MEMORANDUM

Re: Union Pacific Hotel Planned Development Time Extension Request

ACTION REQUIRED: Vote on granting a one-year time extension for a Planned Development approval at 2 South 400 West.

**RE: Record of Decision for Petitions PLNPCM2018-00617 and PLNSUB2018-00618:
Union Pacific Hotel Planned Development and Conditional Building & Site Design
Review at approximately 2 S. 400 West**

SHEET NO.
A1.00

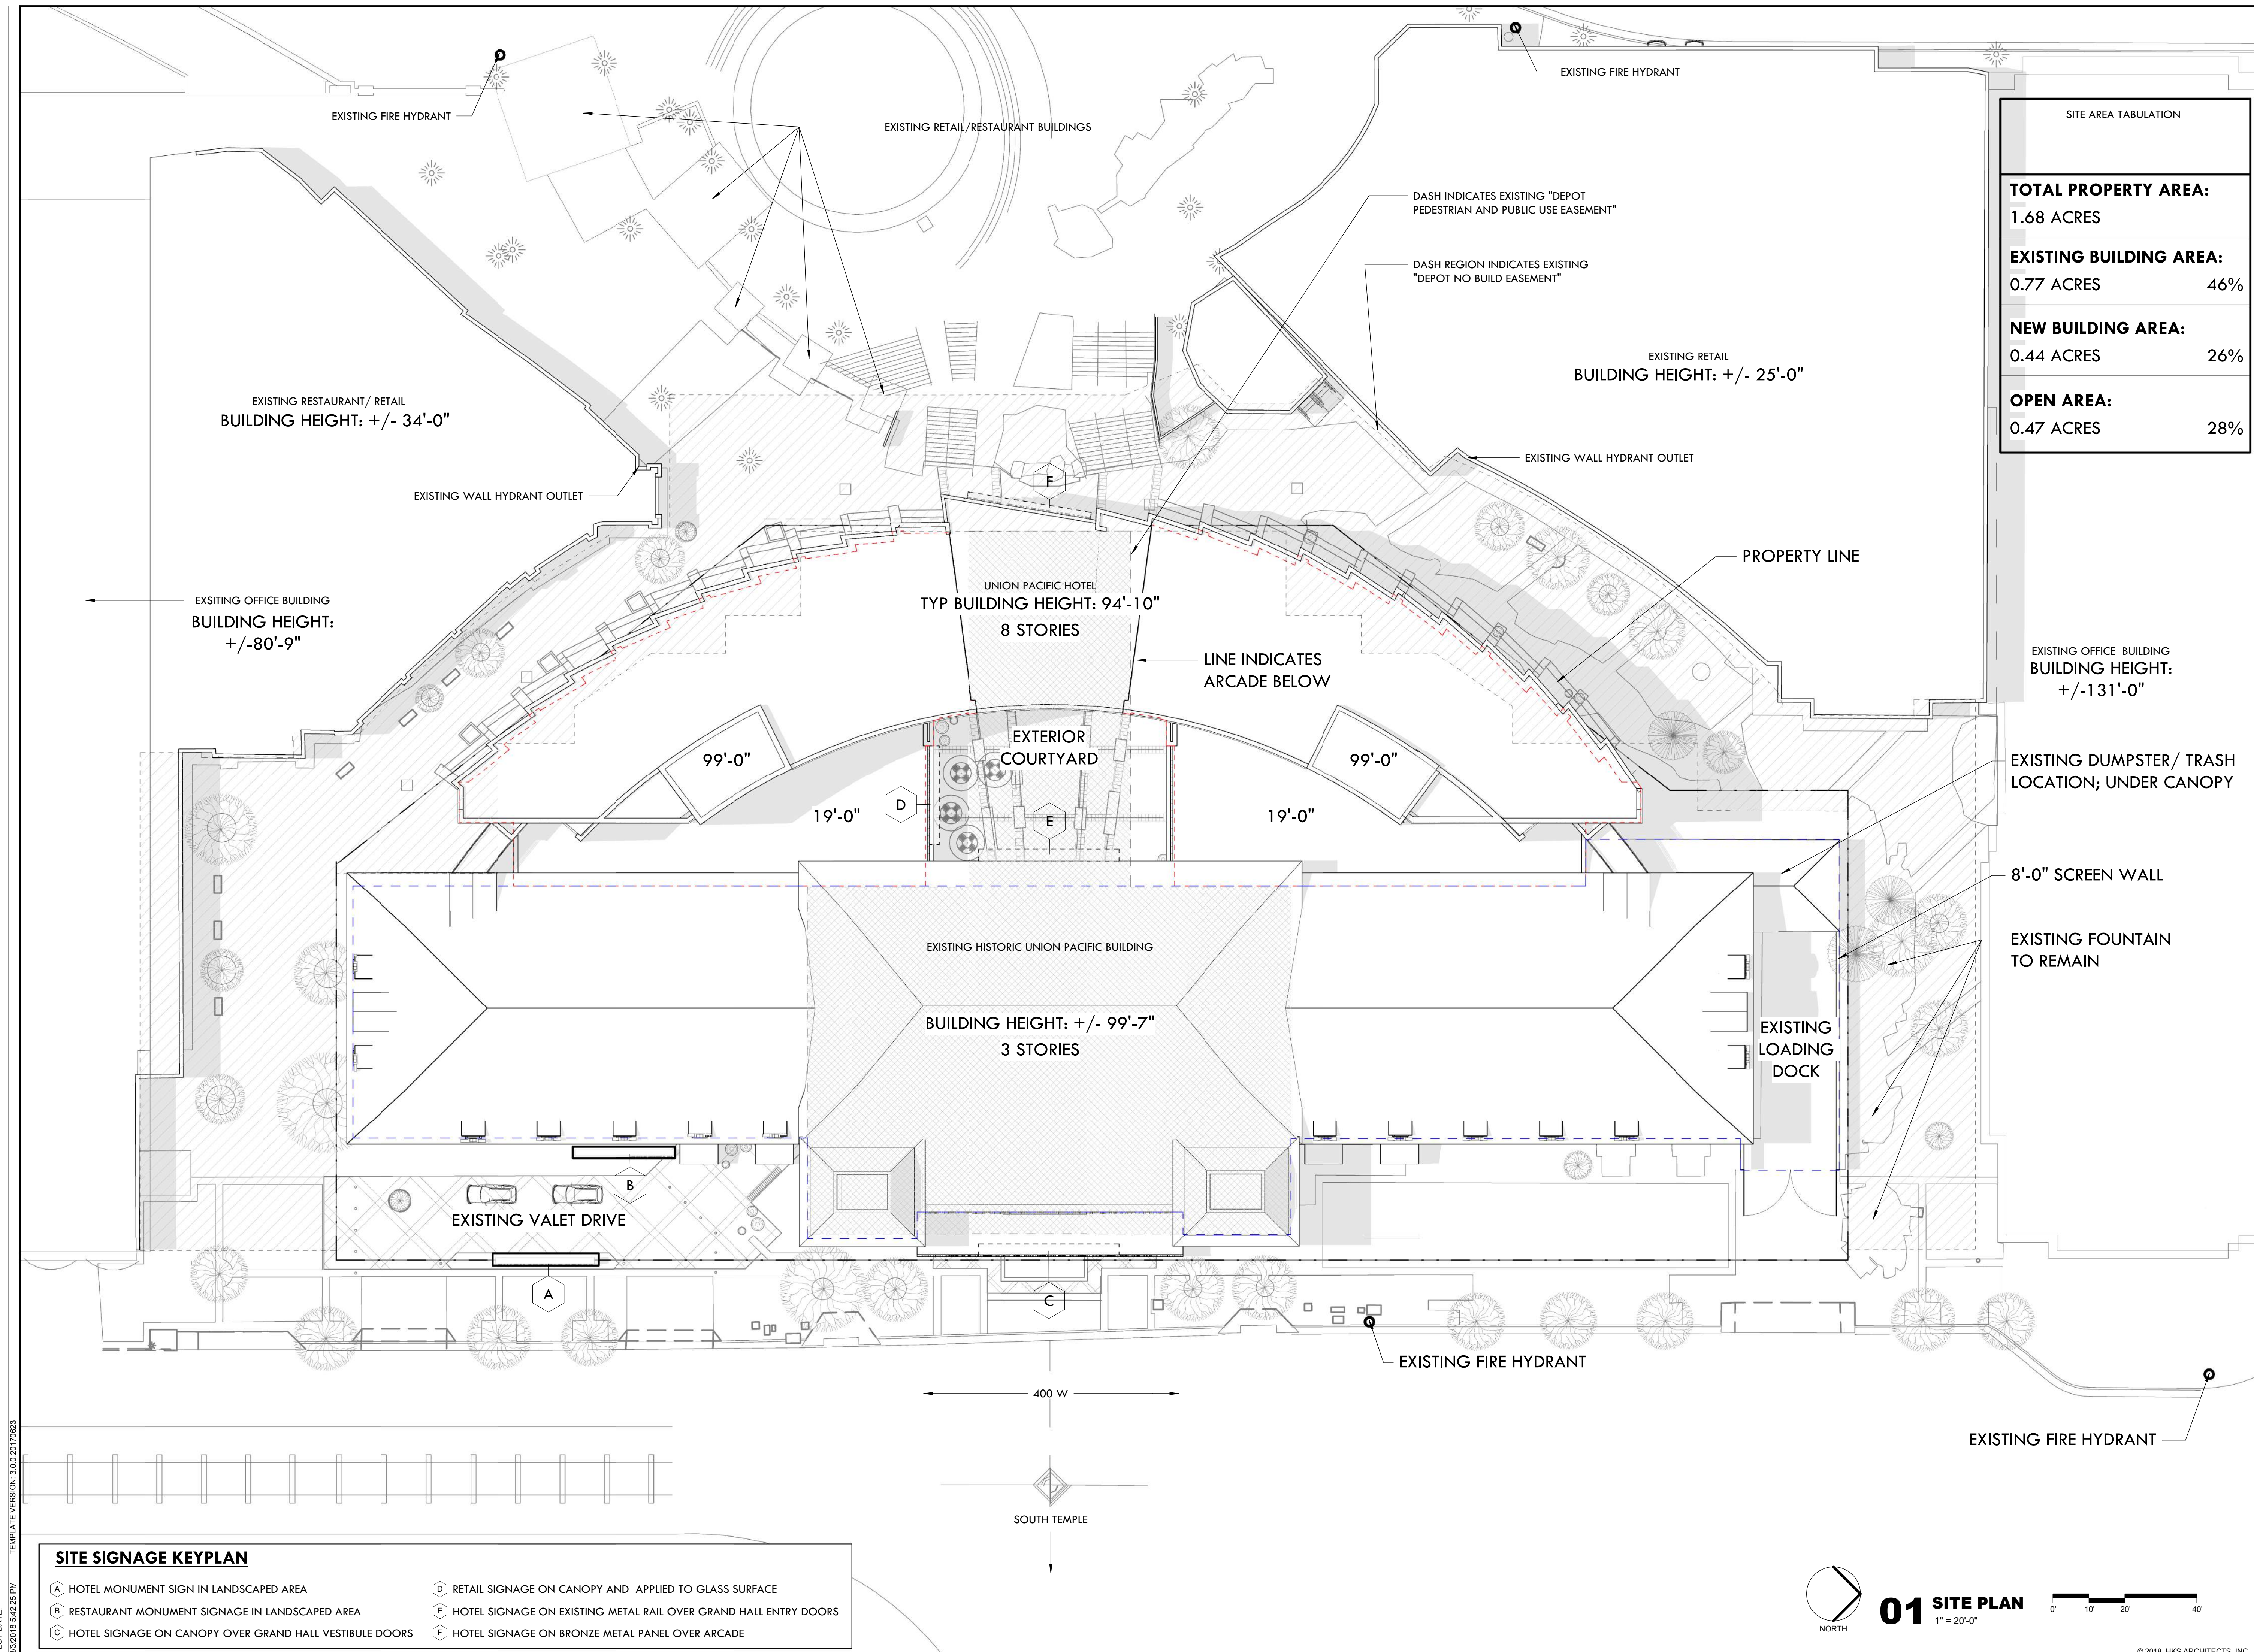
1. The architectural site plan appears to indicate that the building encroaches the property lines on the Northwest, West & Southwest. See sheet A1.00. This also may affect the unprotected openings in accordance with IBC 705.8.
2. The code analysis on sheet A0.01 indicates that the occupancy is R-2. Would the dwelling units contain cooking facilities? This question is being asked because R-2 hotels are non-transient as per IBC 310.4.
3. It is not clear as to how and where the firewalls (fire separations) between the new and the old building occur and what those fire ratings actually are.

SHEET NO.
A2.01

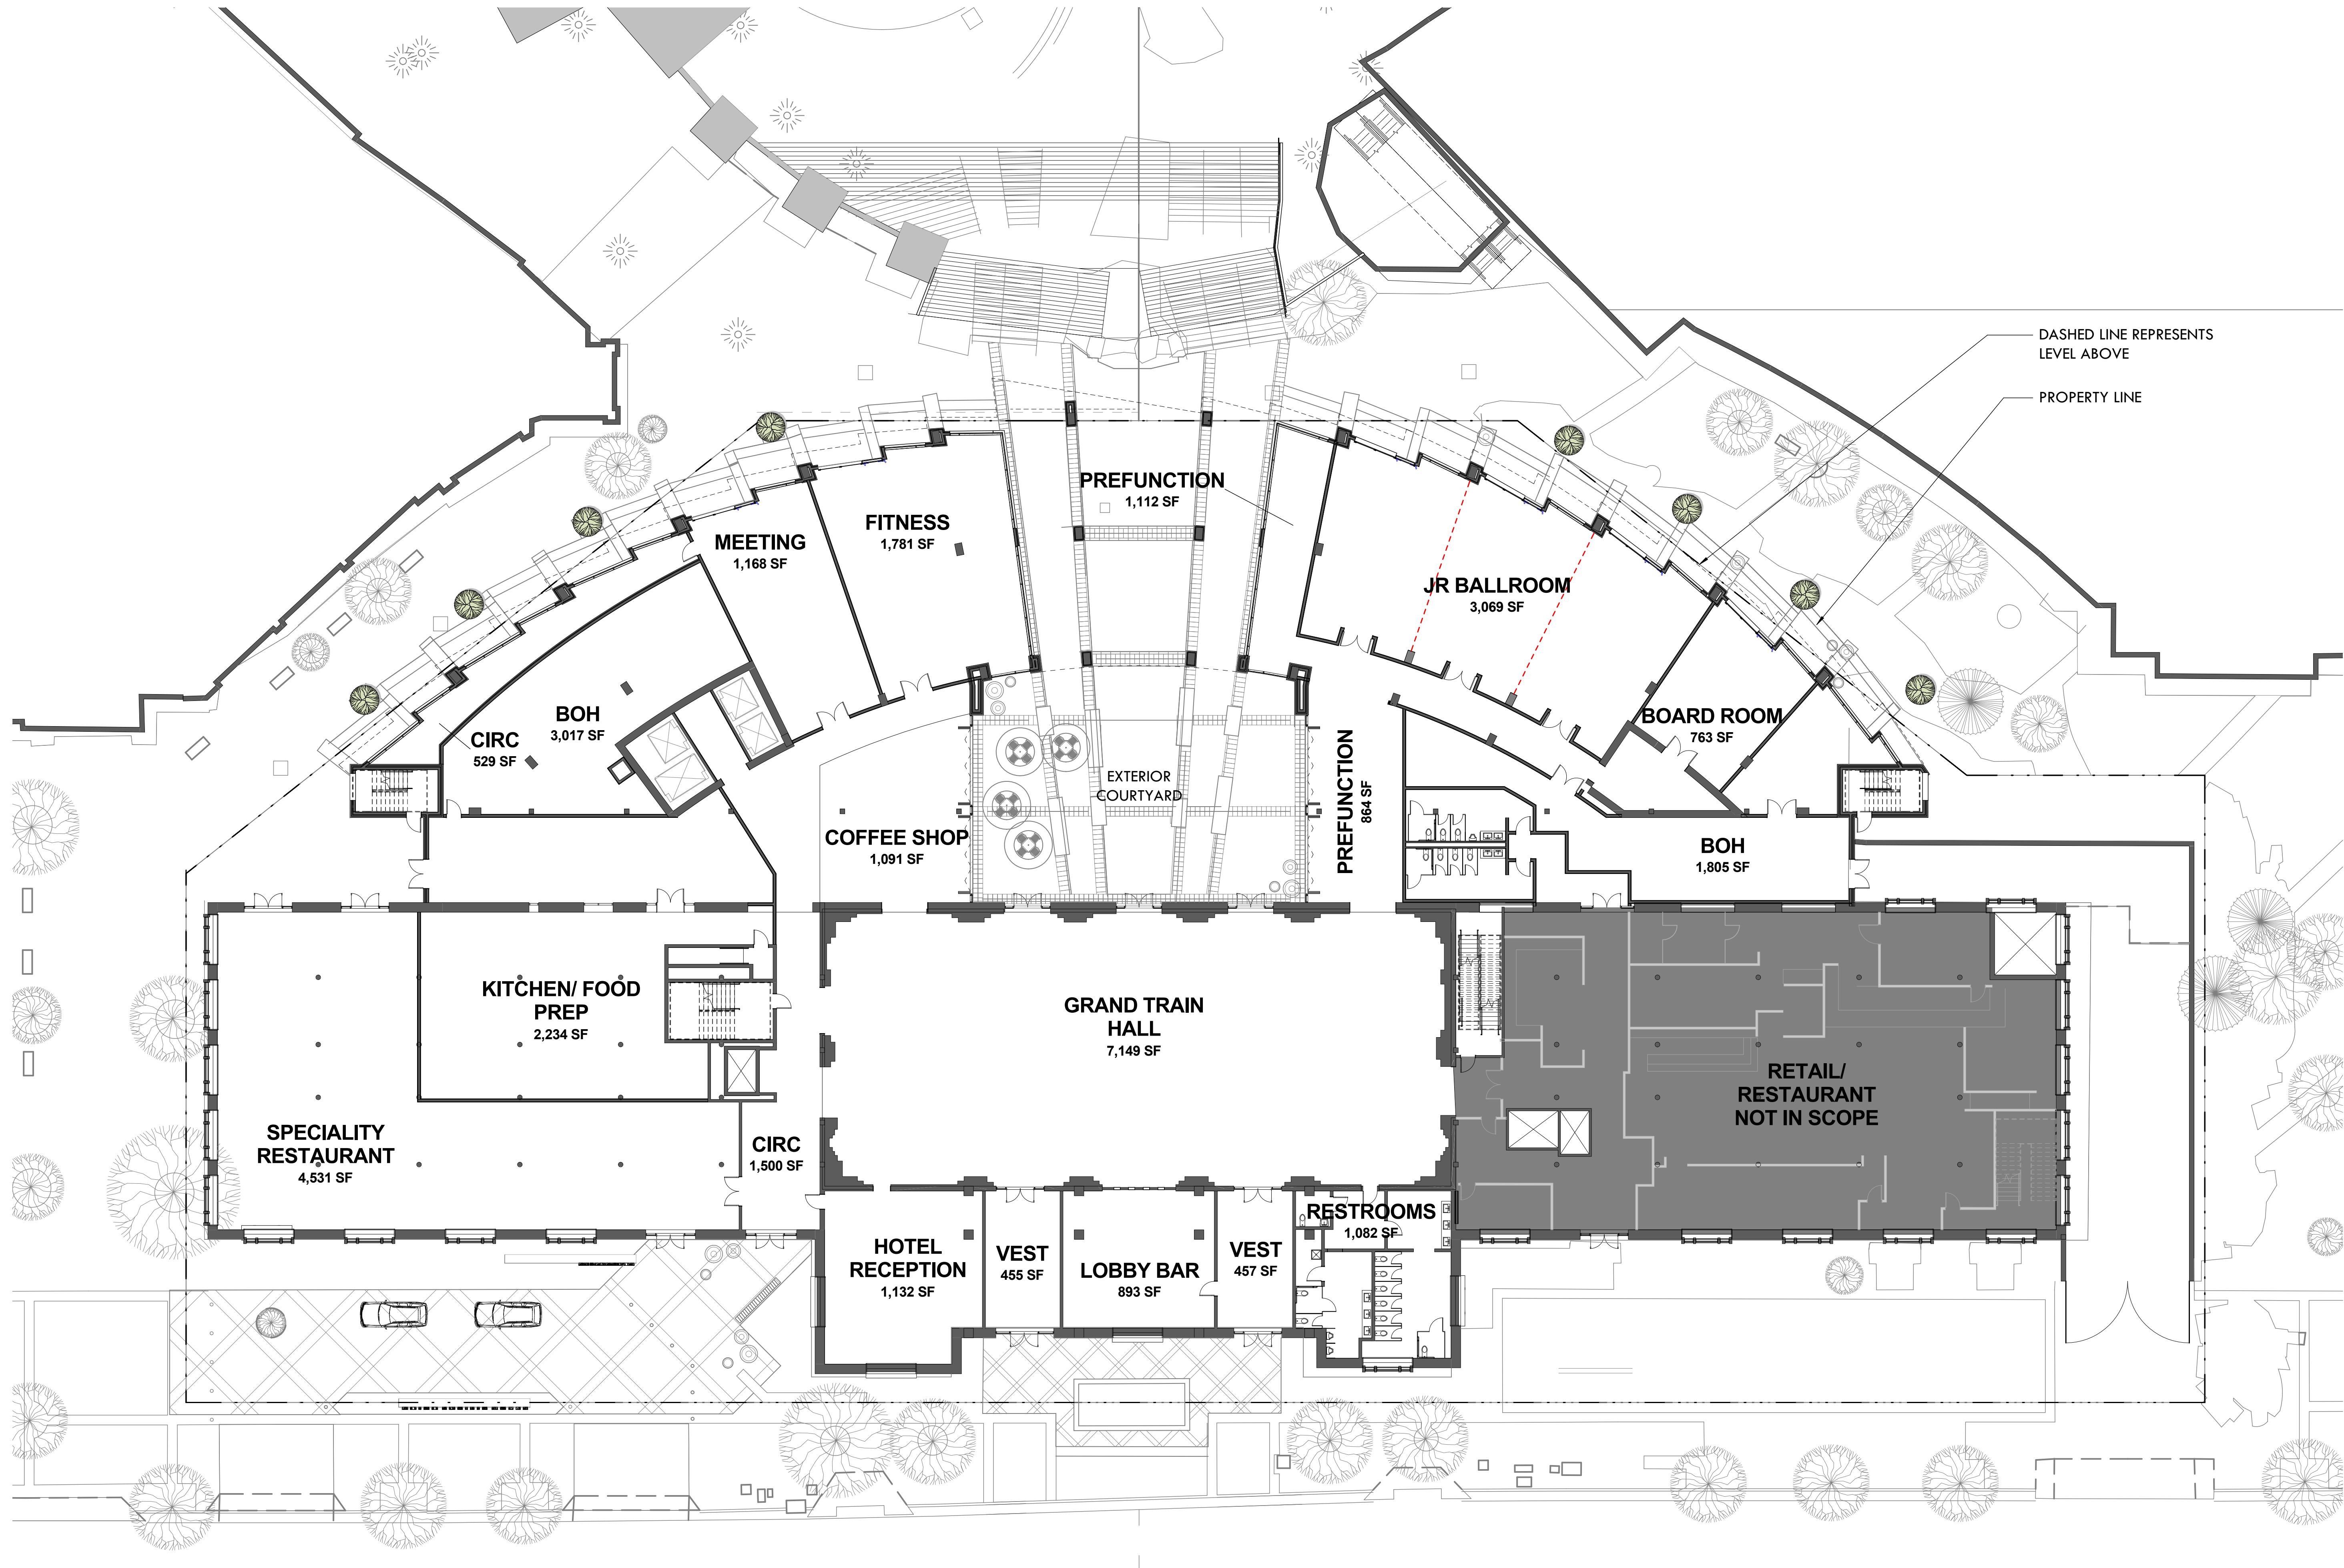
- Where is the aerial apparatus access located at the east side of the existing building it does not show on drawings.
- The fire command center is not located on drawing A2.01.
- Horizontal exit wall is not provided in the high-rise building on drawing A2.02, through A2.08.
- Exiting for the board room and Specialty Bar shall have exiting to the north to the exit stair by a corridor see drawing A2.02.
- We question the length of a corridor which serves 1-BR Suite on drawing A2.04.
